Issue	Date	Event
A	04.08.22	Issue for Section 4.55

Project
28 Lockwood Avenue, Belrose

NEW WINDOWS AND
DOORS SCHEDULE

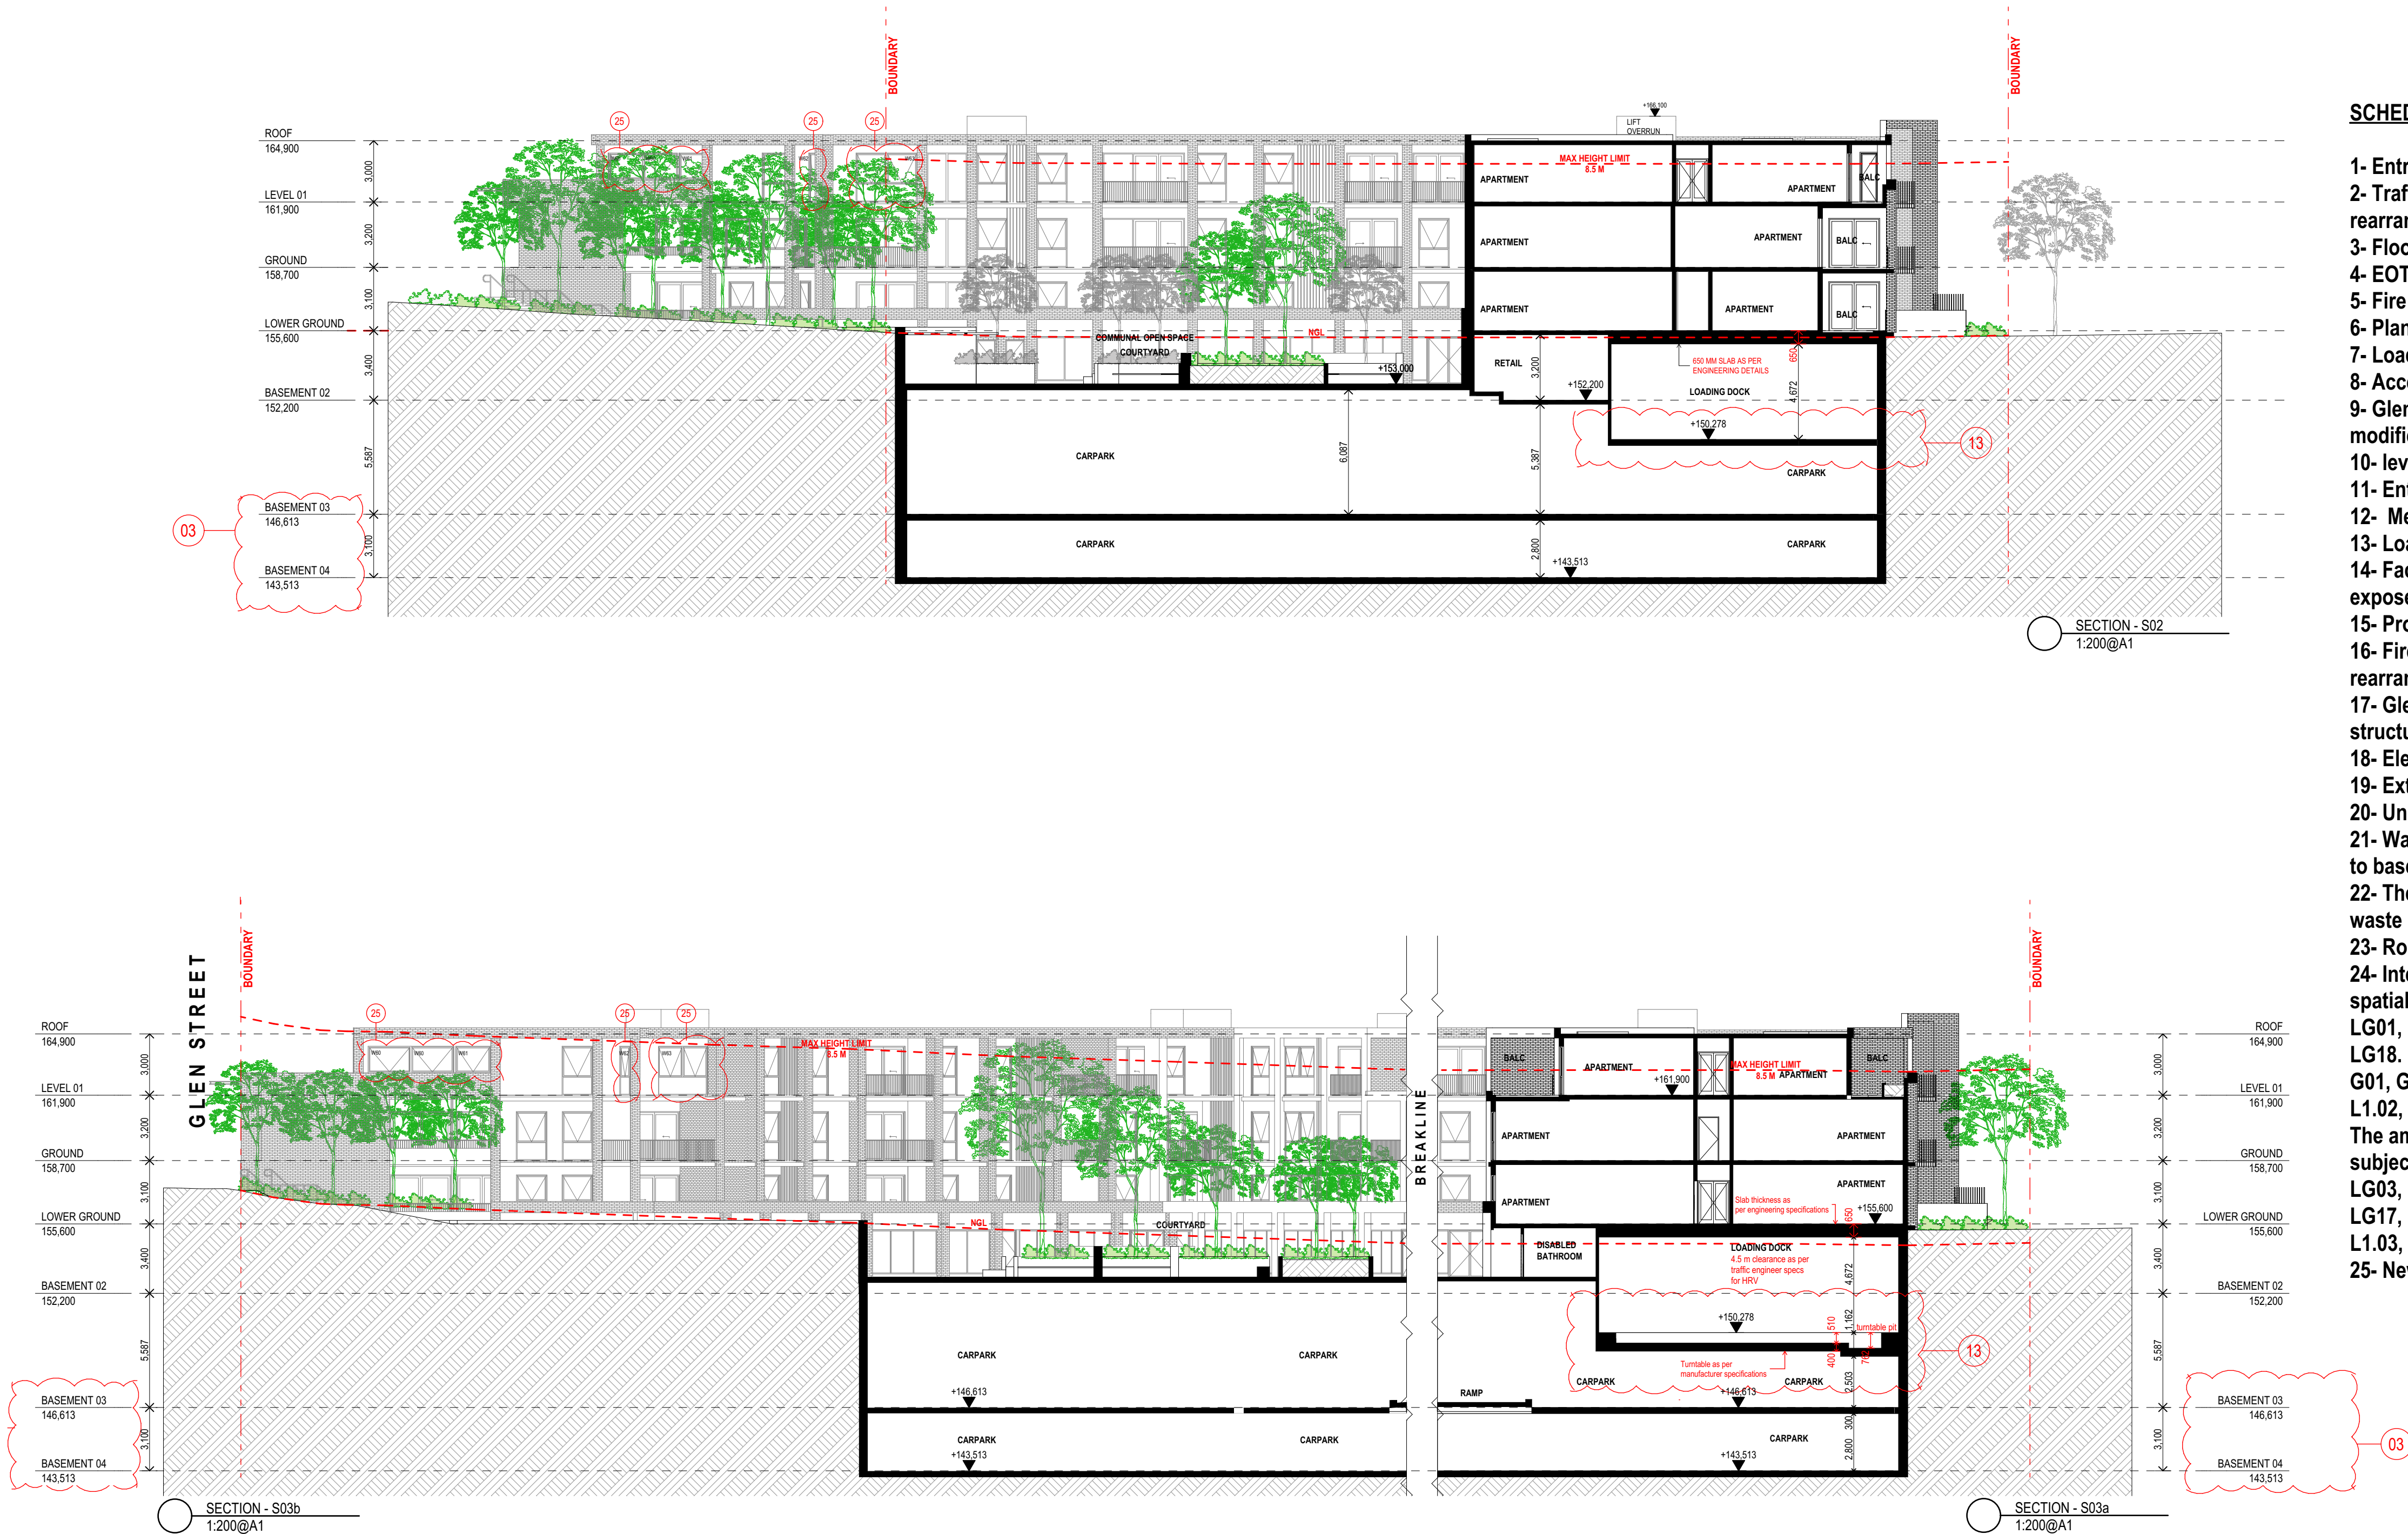
- 25- New aluminum windows and doors.
